Administrative Manual - Team UPDATE - 2013-03-26	4
Administrative Manual - Team UPDATE - 2013-03-26	5
Administrative Manual - Team UPDATE - 2013-02-22	7
Administrative Manual - Team UPDATE - 2013-02-22	8
Administrative Manual - Team UPDATE - 2013-02-19	9
Administrative Manual - Team UPDATE - 2013-02-19	10
Administrative Manual - Team UPDATE - 2013-02-19	11
Administrative Manual - Team UPDATE - 2013-02-19	12
Administrative Manual - Team UPDATE - 2013-02-15	13
Administrative Manual - Team UPDATE - 2013-01-29	14
Administrative Manual - Team UPDATE - 2013-01-25	15
Game Manual - Team UPDATE - 2013-04-23	16
Game Manual - Team UPDATE - 2013-04-16	17
Game Manual - Team UPDATE - 2013-04-09	18
Game Manual - Team UPDATE - 2013-04-09	19
Game Manual - Team UPDATE - 2013-04-02	20
Game Manual - Team UPDATE - 2013-04-02	21
Game Manual - Team UPDATE - 2013-03-19	22
Game Manual - Team UPDATE - 2013-03-12	23
Game Manual - Team UPDATE - 2013-03-05	24

Administrative Manual - Team UPDATE - 2013-03-26

Game Manual - Team UPDATE - 2013-04-23

Figure 2-9: ROBOT Using Belay Device (UPDATED)

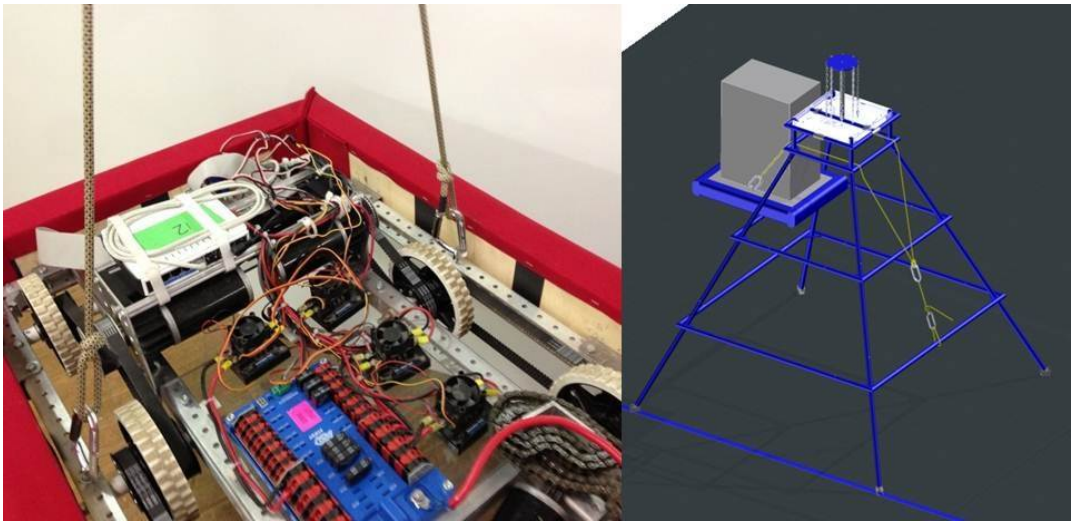
Teams may have to remove their ROBOT from the PYRAMID after the MATCH is over with the aid of a *FIRST* supplied belay system, per [G04](#). The belaying device acts as a brake to prevent accidentally dropped ROBOTS from causing injuries to teams. The device attaches to the ROBOTS with two carabiners or loops of rope. Teams must supply two attachment points for the belaying device to mount to their ROBOTS, per R10. The belaying rope is fed through a brake that is anchored to the lowest rung on the opposite side of the PYRAMID from the ROBOT. It is then fed through the PYRAMID top and down the other side to be attached to the ROBOT. There is a "bridle" that splits the rope into two sections, which are 90 in. long.

Only trained event staff are allowed to use the belaying device.

Figure 3-5b: Offset Plane from PYRAMID Base

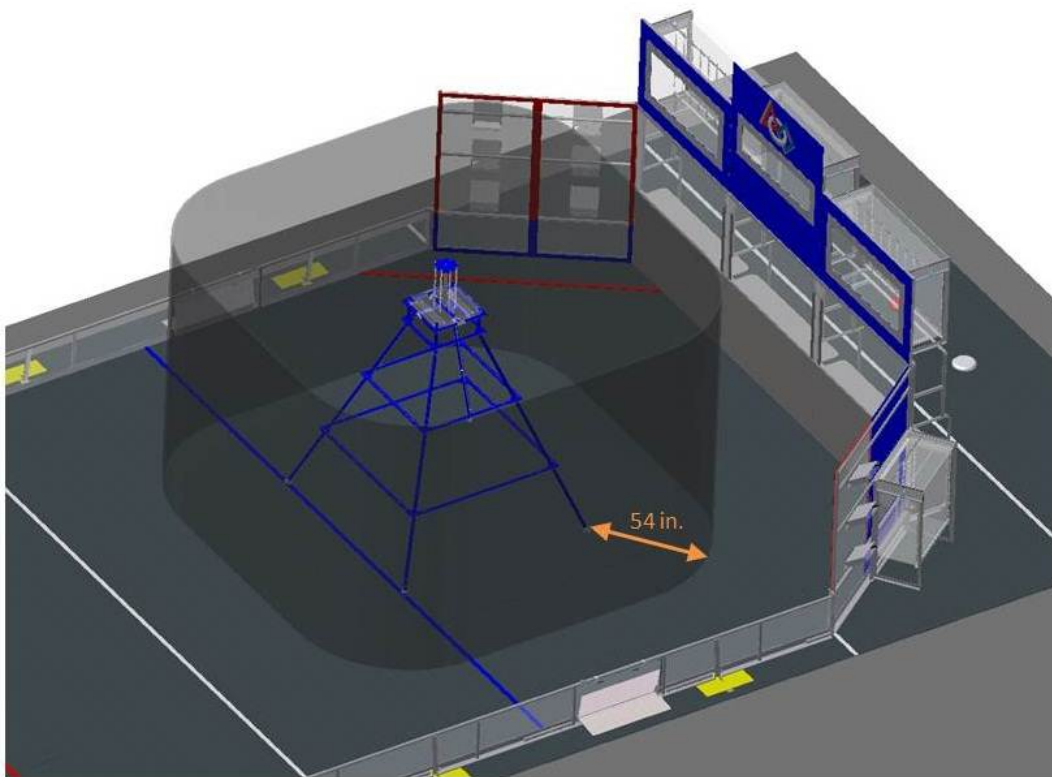
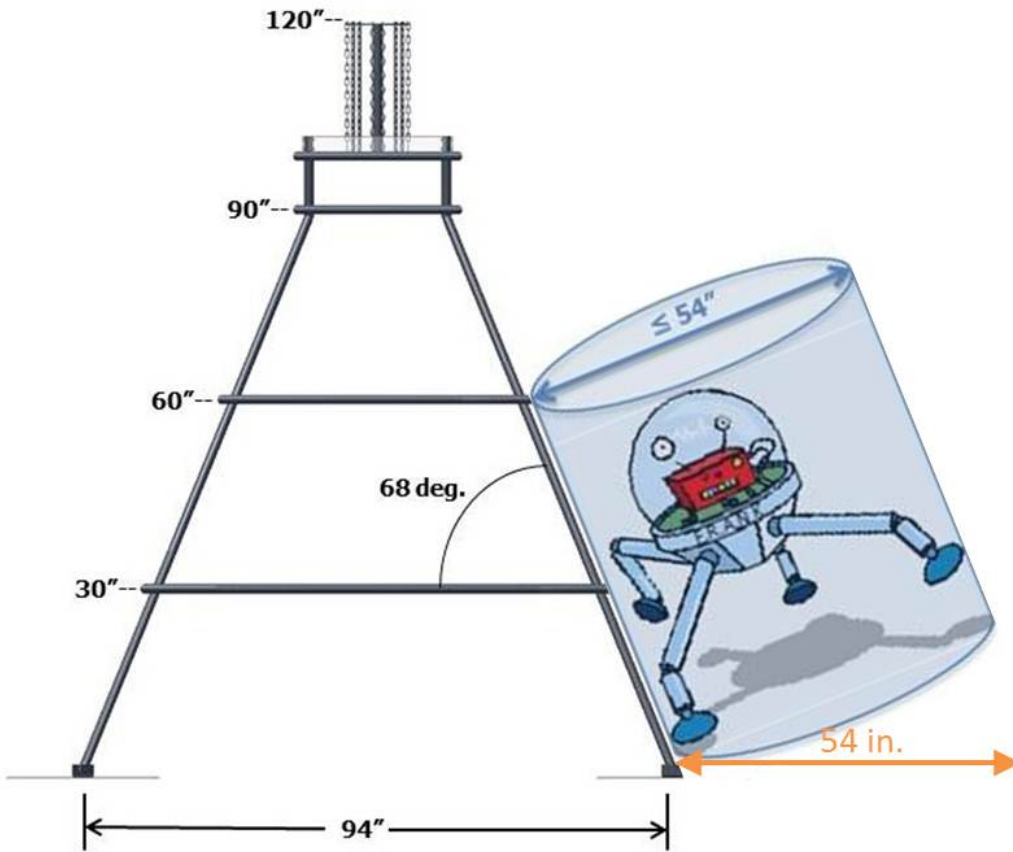
While in contact with the PYRAMID, a ROBOT

- A. may not have its horizontal dimensions exceed a 54 in. diameter vertical cylinder relative to the ROBOT and
- B. may not extend any part of itself beyond a vertical plane defined by a perimeter offset from the base of the PYRAMID by 54 in., see Figure 3-5b and Figure 3-5c.

Figure 4-1: FRAME PERIMETER Length Calculations

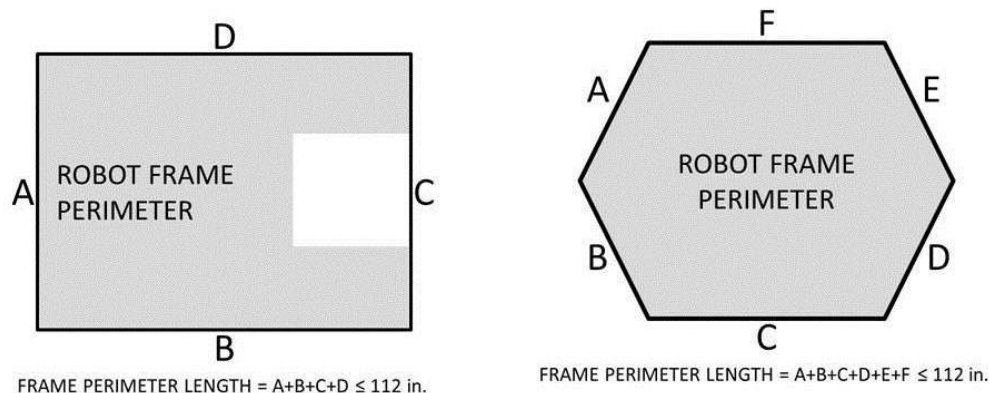
The ROBOT must satisfy the following size constraints:

- A. total length of the FRAME PERIMETER sides may not exceed 112 in. (see [Figure 4-1](#) for examples),
- B. PLAYING CONFIGURATION horizontal dimensions may never exceed a 54 in. diameter vertical cylinder (see [G23](#) and [G23-1](#)), and
- C. height may never exceed 84 in. tall.

Figure 4-2: BUMPER Corner Examples (UPDATED)

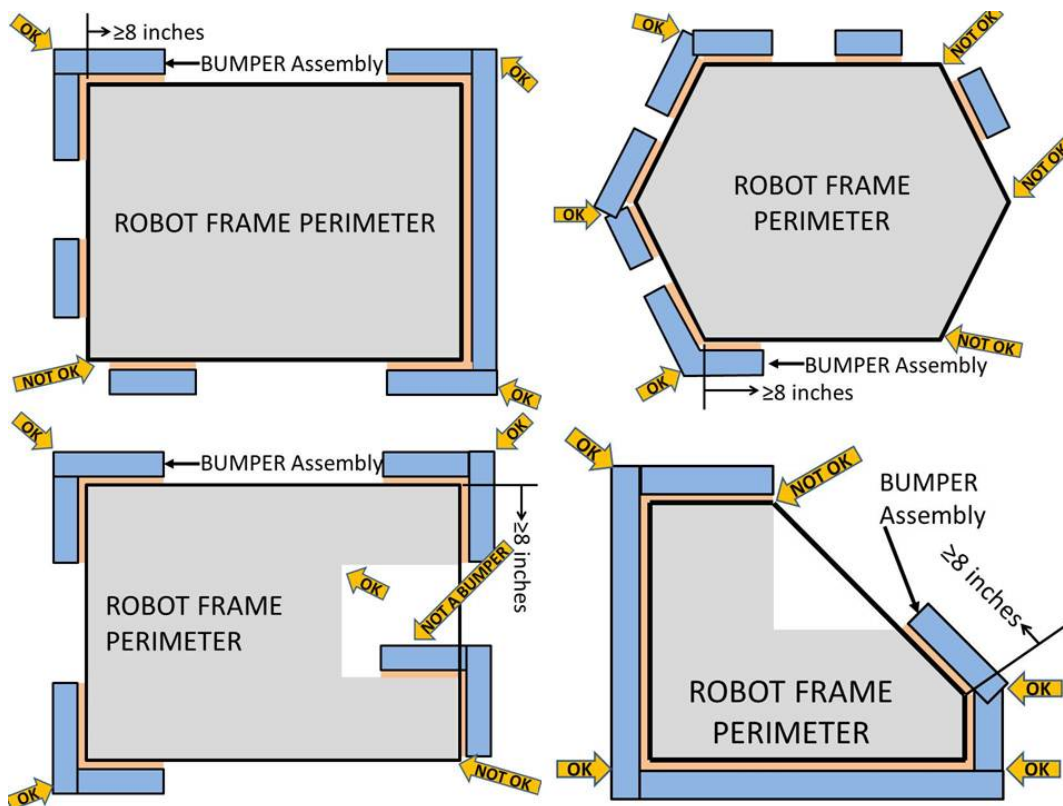
ROBOTS are required to use BUMPERS to protect all outside corners of the FRAME PERIMETER. For adequate protection, at least 8 in. of BUMPER must be placed on each side of each outside corner (see [Figure 4-2](#)).

The dimension defined in R22 is measured along the FRAME PERIMETER. The portion of the BUMPER that extends into the corner is not included in the 8 in. requirement.

Figure 2013-01-15

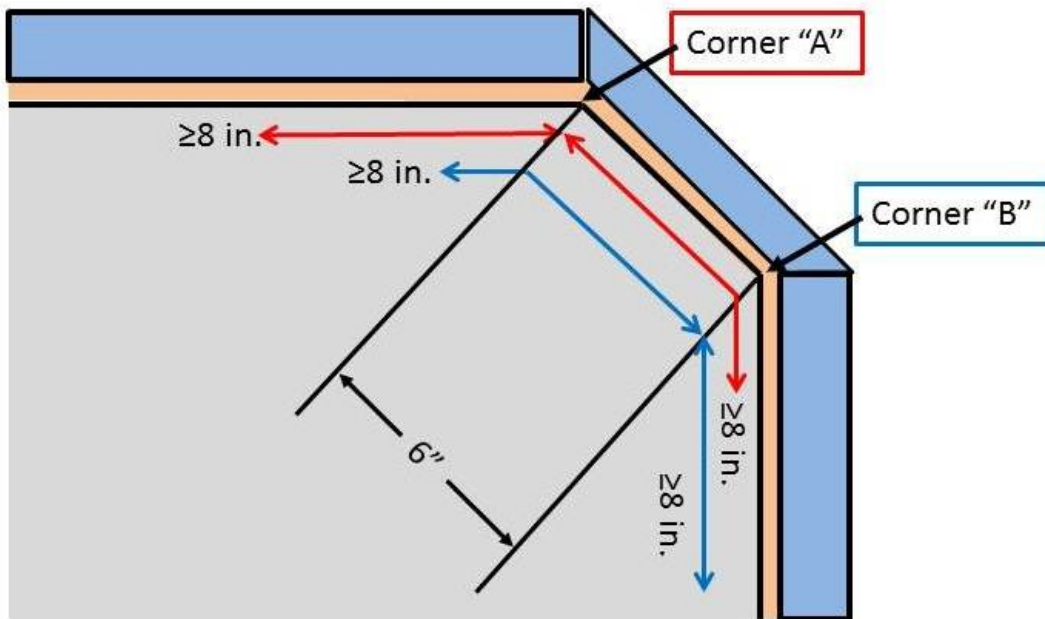
The Inspectors also asked for clarification on the 8 in. BUMPER requirement of R22. As stated in the Blue Box on R22, the dimension is measured along the FRAME PERIMETER. In Figure 2013-01-15 below, the edge of the FRAME PERIMETER between Corner A and Corner B is only 6 in. To satisfy the 8 in. requirement for Corner A, there must be at least 8 in. of BUMPER in each direction. Thus, the measurement along the 6 in. side would continue past Corner B for 2 more inches.

Figure 3-4: PYRAMID Levels

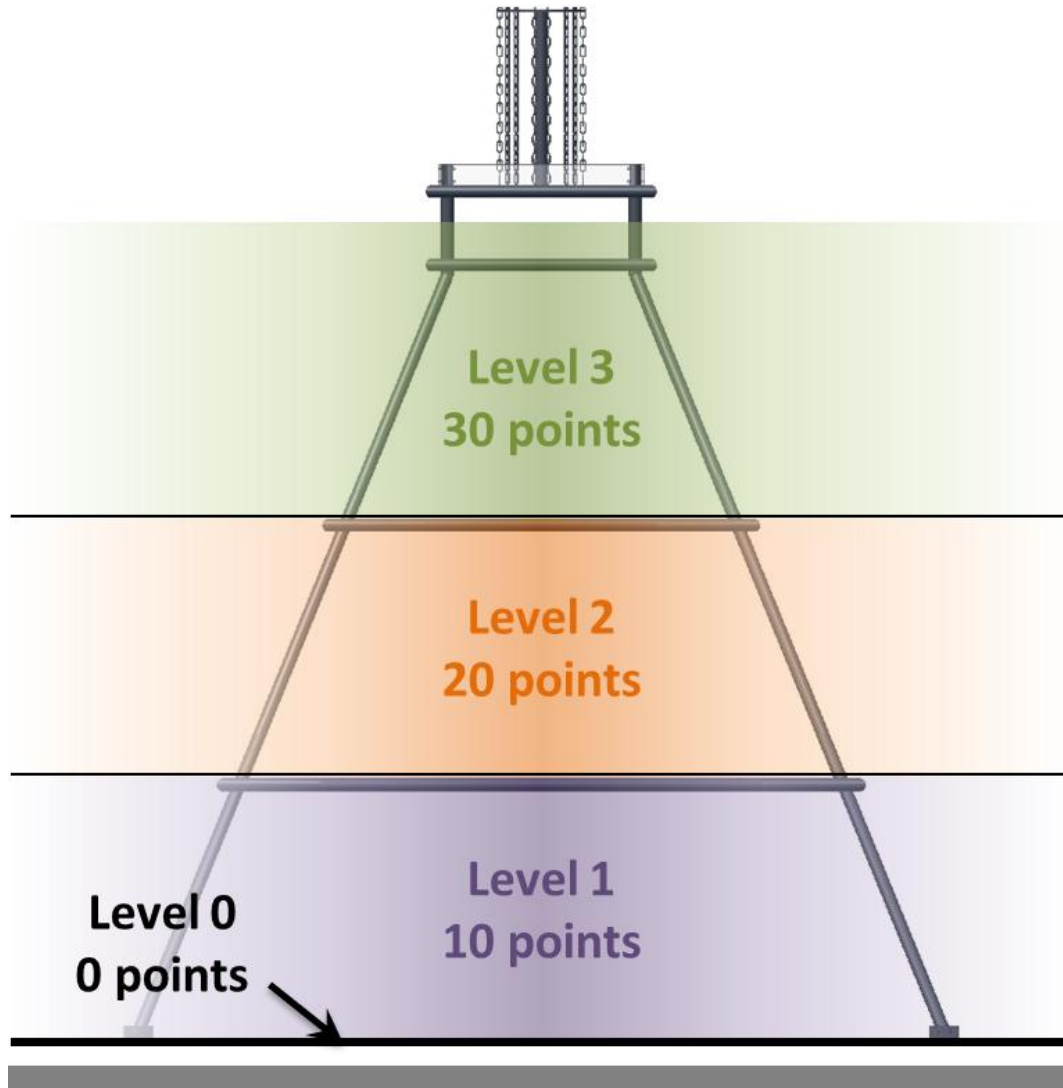
Points are awarded for the highest Level achieved for every ALLIANCE ROBOT that CLIMBS its PYRAMID. The Level to which a ROBOT has CLIMBED is determined by the lowest point of the ROBOT (in relation to the FIELD) **at the point in which final scores are assessed per [Section 3.2.4](#)**. CLIMB point values and Levels are defined in [Figure 3-4](#).

As competition at the *FIRST* Championship is typically different from that during the competition season, *FIRST* may alter the value of CLIMBING at the *FIRST* Championship by up to ten (10) points per Level.
